# RECORD OF DECISION

General Electric Co. Auburn  
State Superfund Project  
Auburn/Aurelius, Cayuga County  
Site No. 706006  
March 2016

Prepared by  
Division of Environmental Remediation  
New York State Department of Environmental Conservation

**FIGURE 4**

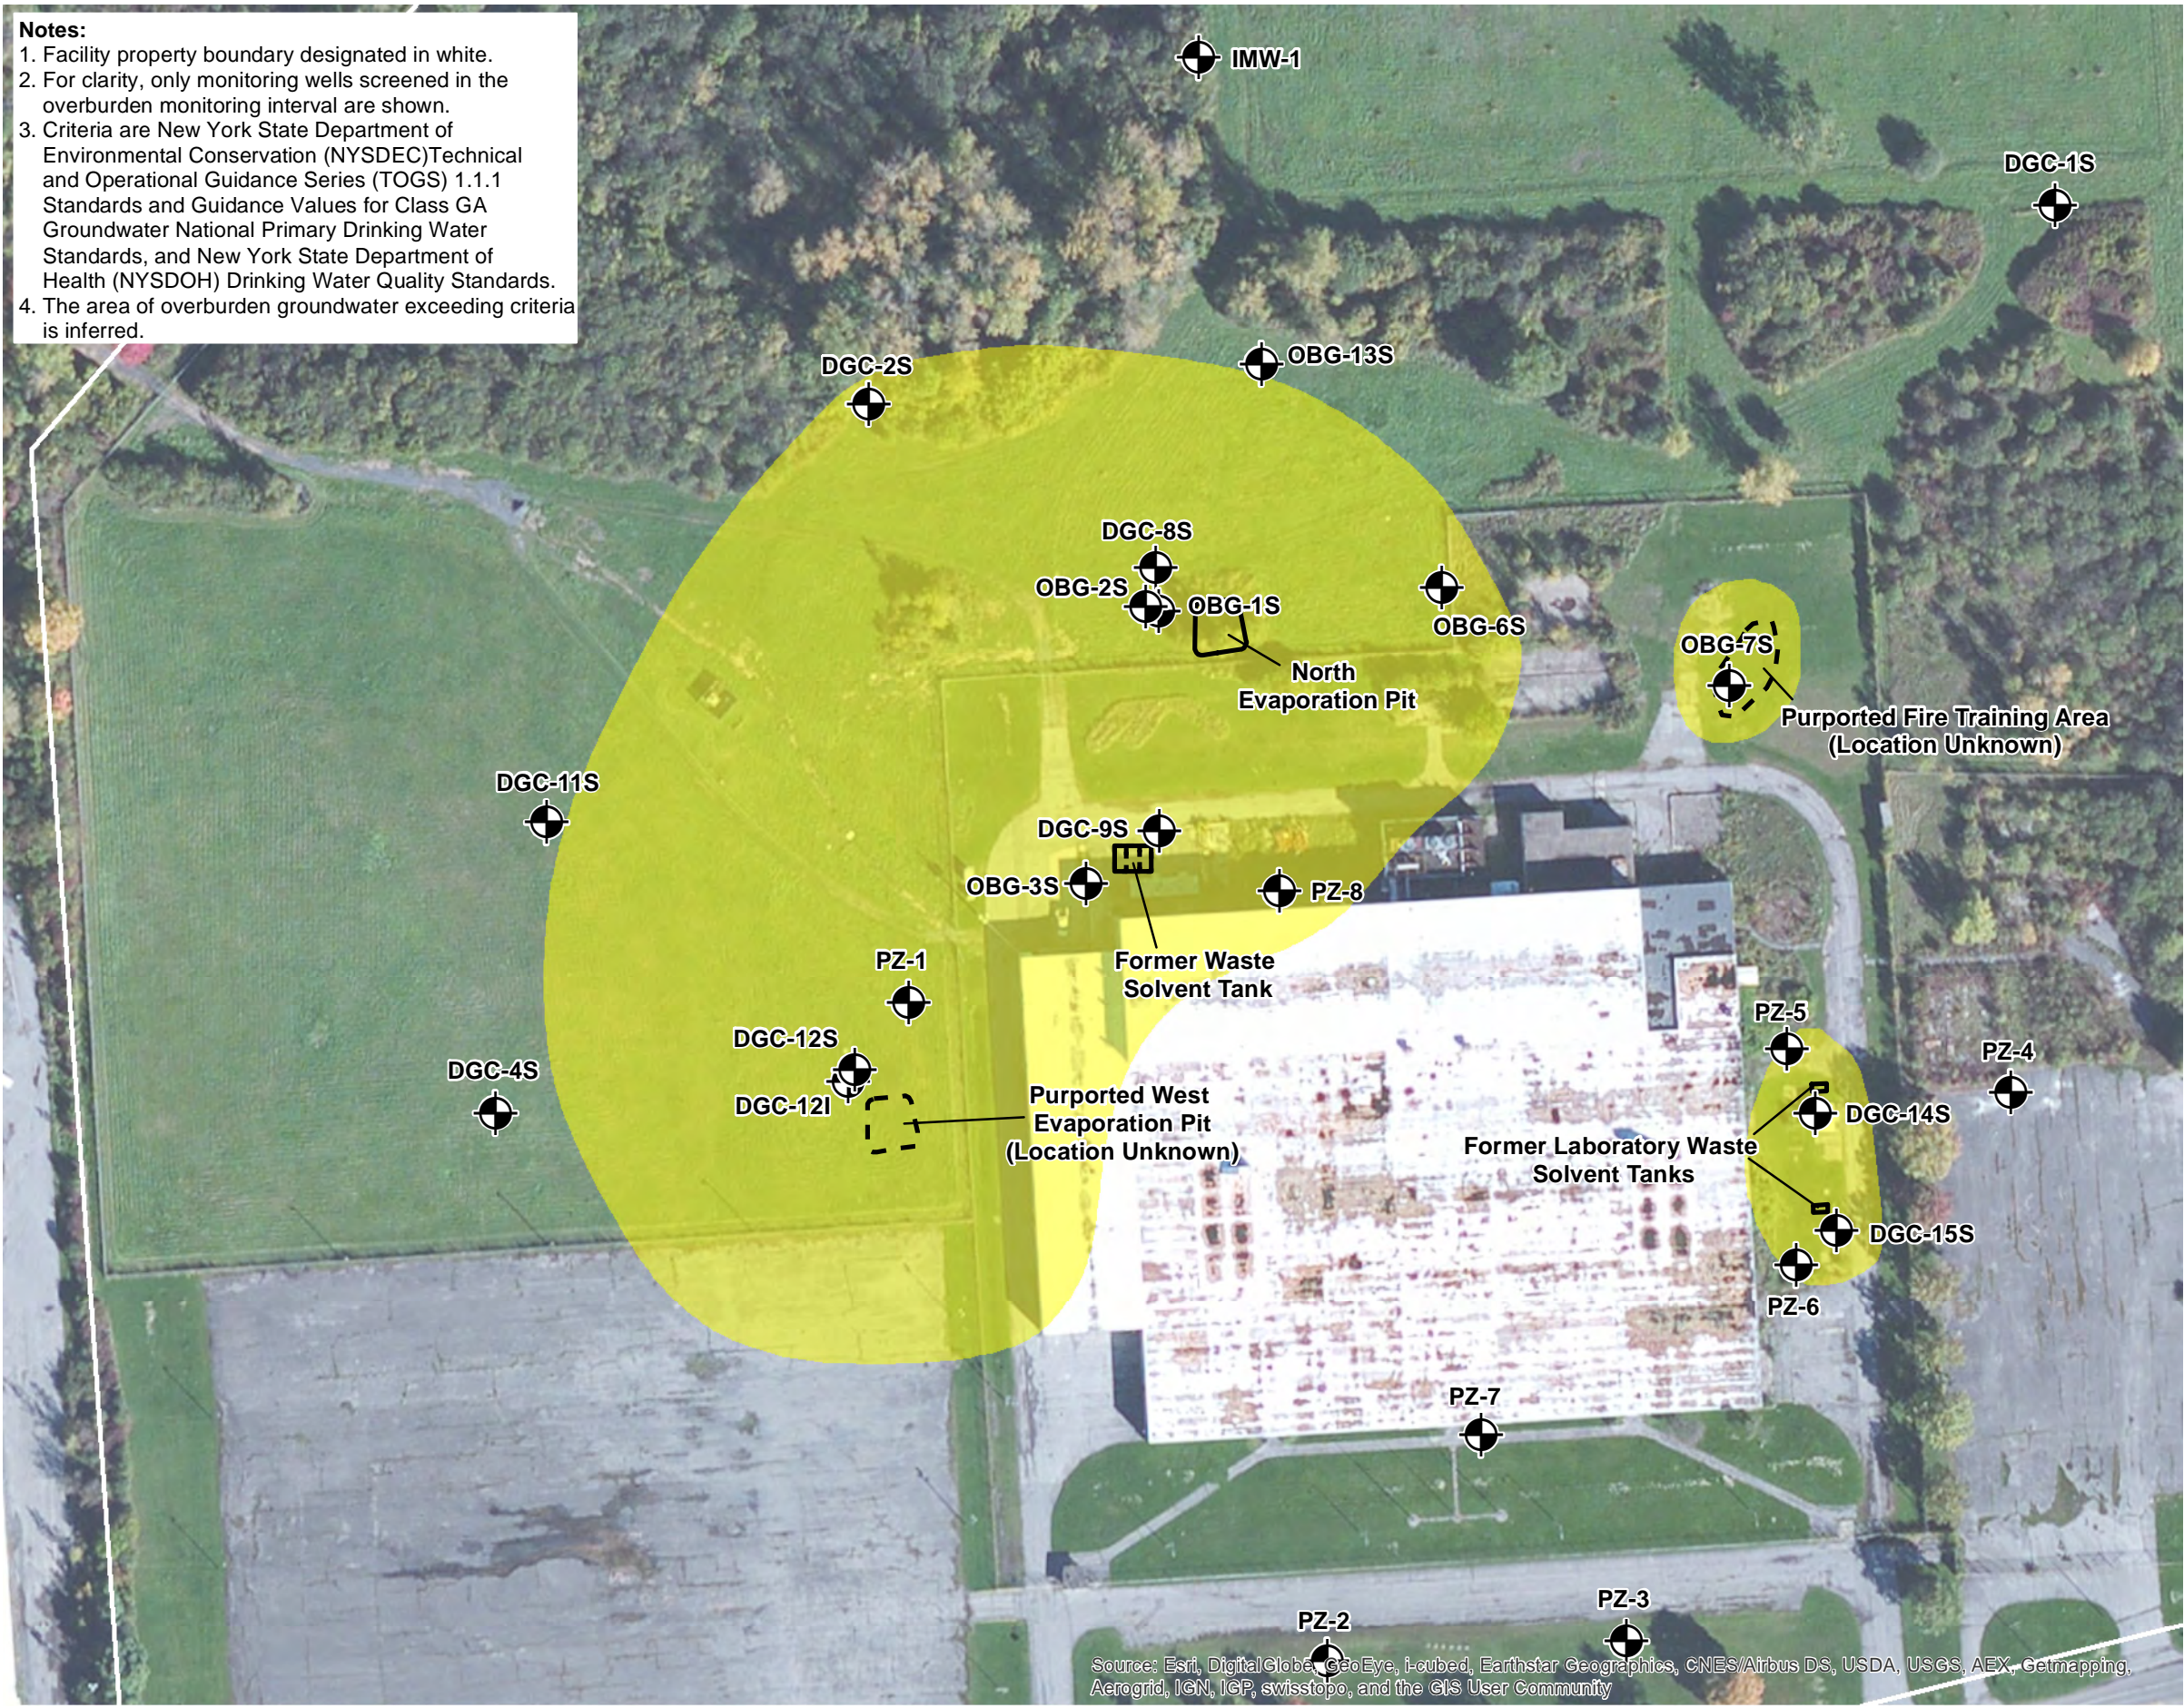
The extent of VOCs in the overburden groundwater at the former Powerex facility has been established as being limited to within the property boundary, as clearly shown on Figure 4 of the PRAP. The areas of overburden groundwater contamination are located at and near the source areas, and do not extend to the facility boundary in any direction, including to the west.

As stated in the PRAP and now this ROD an evaluation of the potential for soil vapor intrusion will be undertaken during the design phase. The technical basis for this decision was due to the lack of SVI information in the western area of the site. The NYSDOH will take into consideration the information presented in the comment and in consultation with the DEC and EPA evaluate the need to conduct an additional SVI evaluation.

**FIGURE 5**

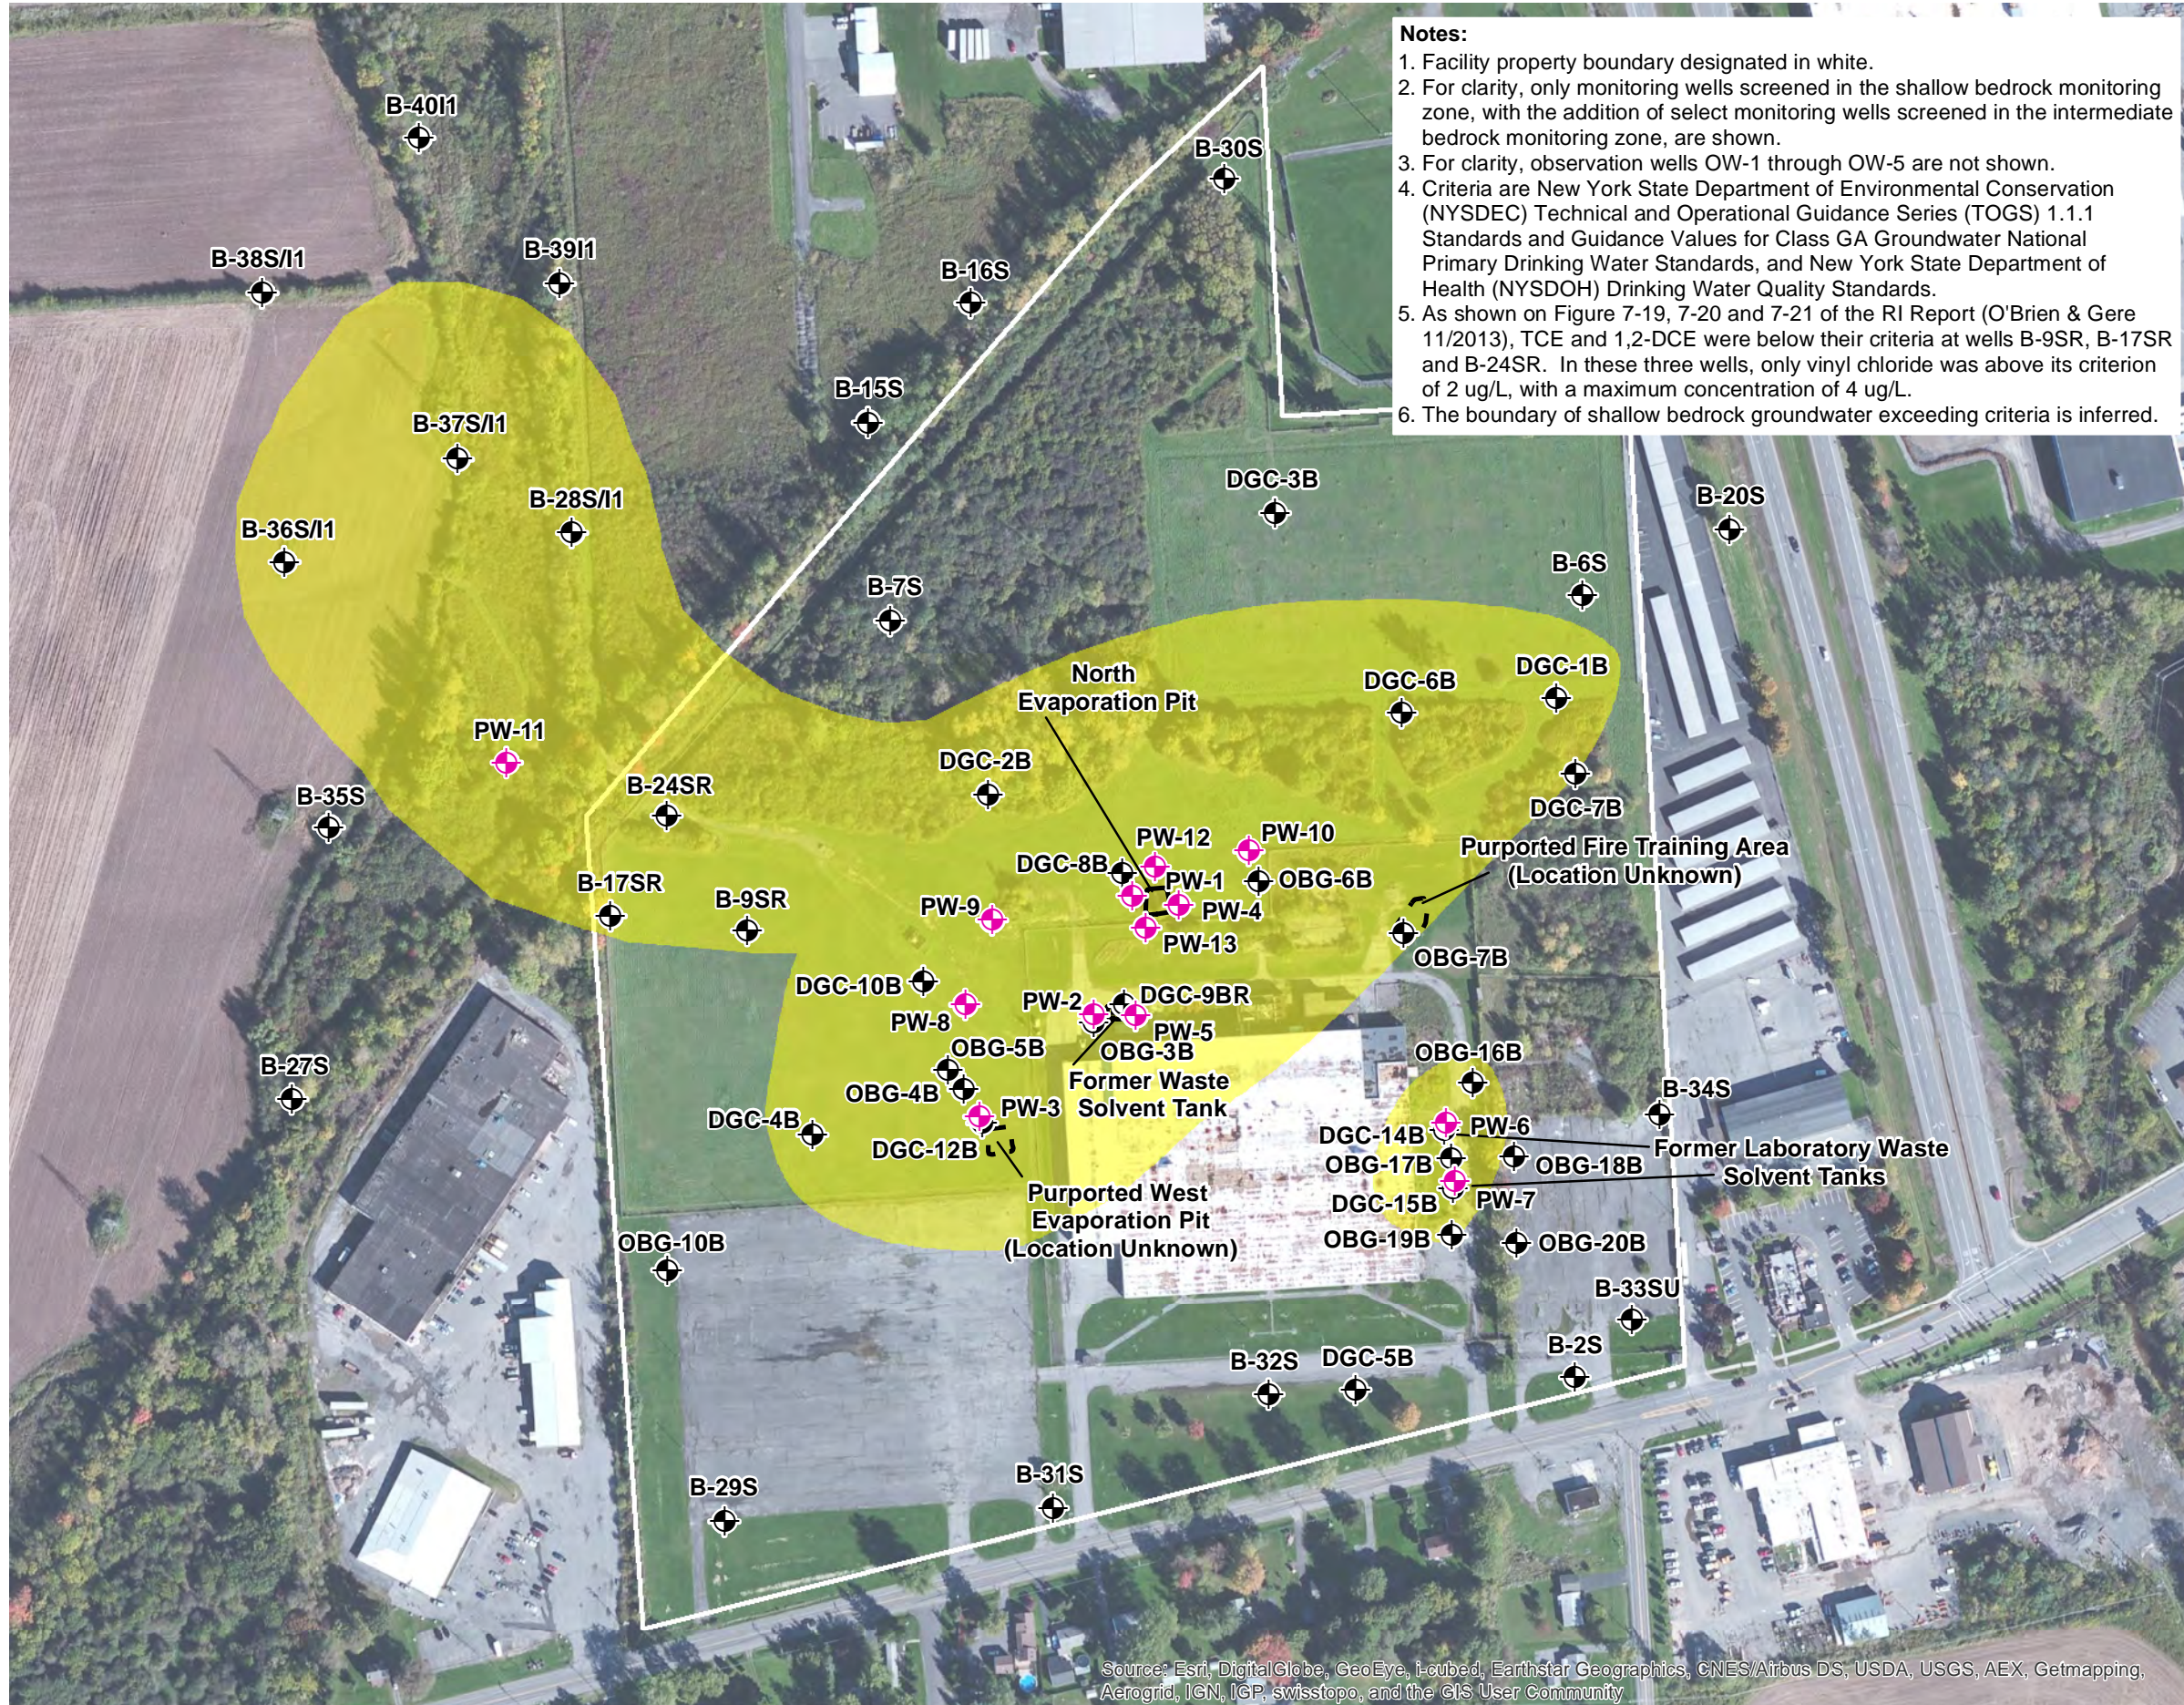
Figure 5 of the PRAP (which is based on Figure 5-5 of the FS Report) shows the extent of VOCs in the shallow bedrock groundwater. As shown on that figure, the area with VOC concentrations in the shallow bedrock above the groundwater standards extends to the northwest of the former Powerex facility, but not to the buildings on the adjacent property(ies). An understanding of the VOC concentrations in the shallow bedrock is provided by Figures 7-19, 7-20 and 7-21 of the RI Report, which are included in Exhibit C and present isoconcentration contour maps for TCE, cDCE and VC, respectively. There are three shallow bedrock monitoring wells located in the northwestern corner of the facility (B-9SR, B-17SR and B-24SR). These three wells are sampled regularly. The concentration trends for TCE, cDCE and VC are shown in Exhibit D, and reductions have been observed in all three wells. Most recently, TCE was not detected in 2015 in any of these three wells; the concentrations of cDCE were all below the groundwater standard, and the concentrations of VC were only slightly above the groundwater standard.
